**ANN ARBOR WASTEWATER TREATMENT PLANT  
FACILITIES RENOVATIONS**

**ITB No. 4191**

**ADDENDUM NO. 2  
DECEMBER 12, 2011**

ISSUED STATUS: BID SET  
DATE: NOVEMBER 2011  
SHEET: C01-31  
CAD REF. NO. \_\_\_\_\_

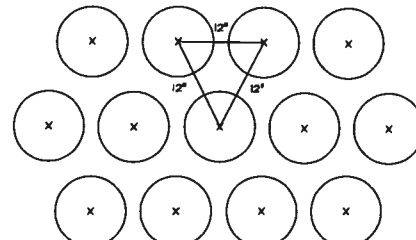
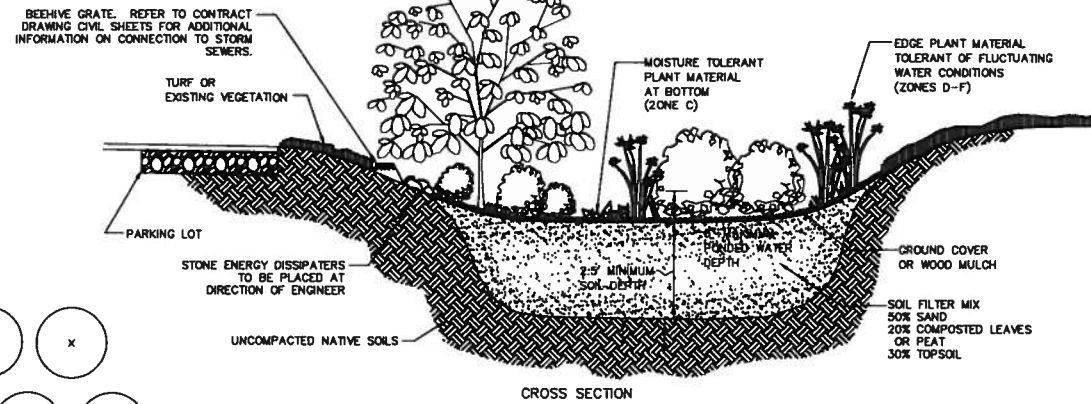
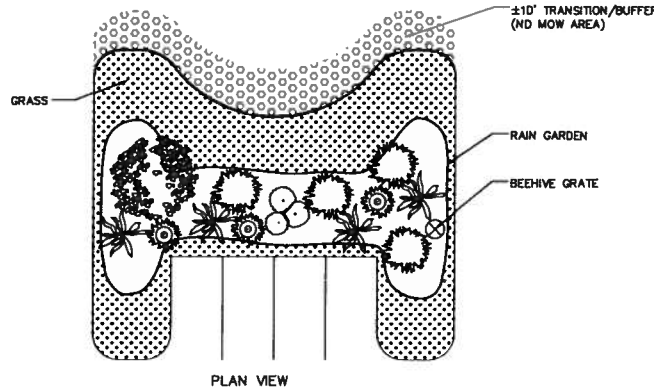
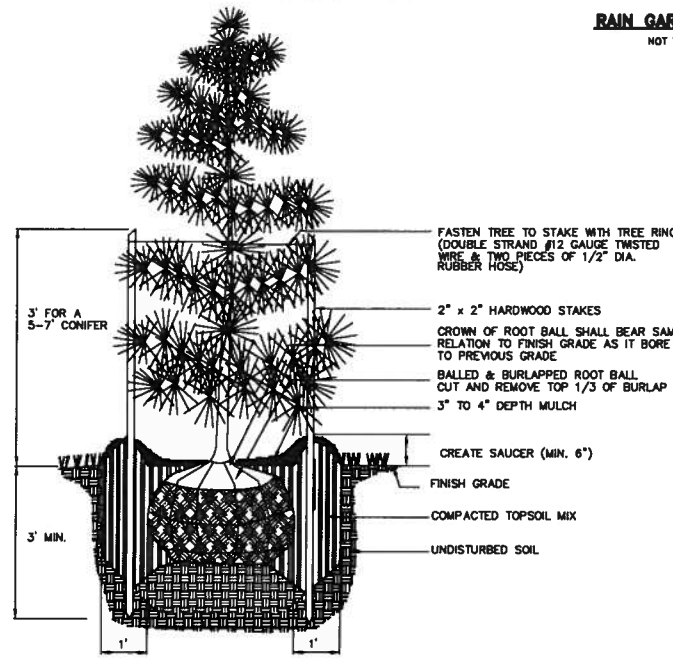
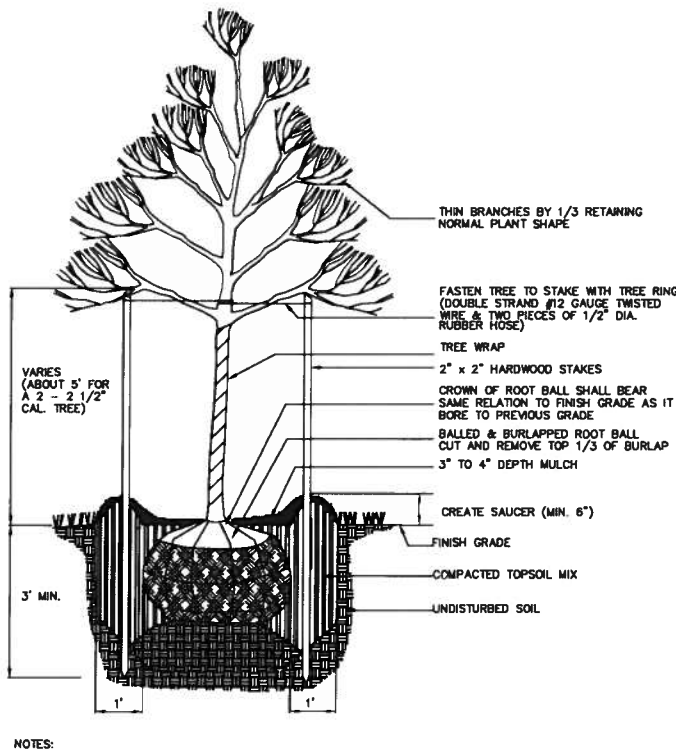
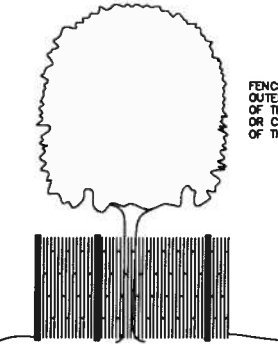
**Bidder's Question:** Sheets C01-27 & 31

What are the quantities of plugs for various planting zones (C, D, E, F) and rain gardens (A, B, D, D). There only appear to be total quantities, but not individual species shown on the Plant Schedules.

*Response: See revised Sheets C01-27 and C01-31 attached to this Addendum..*
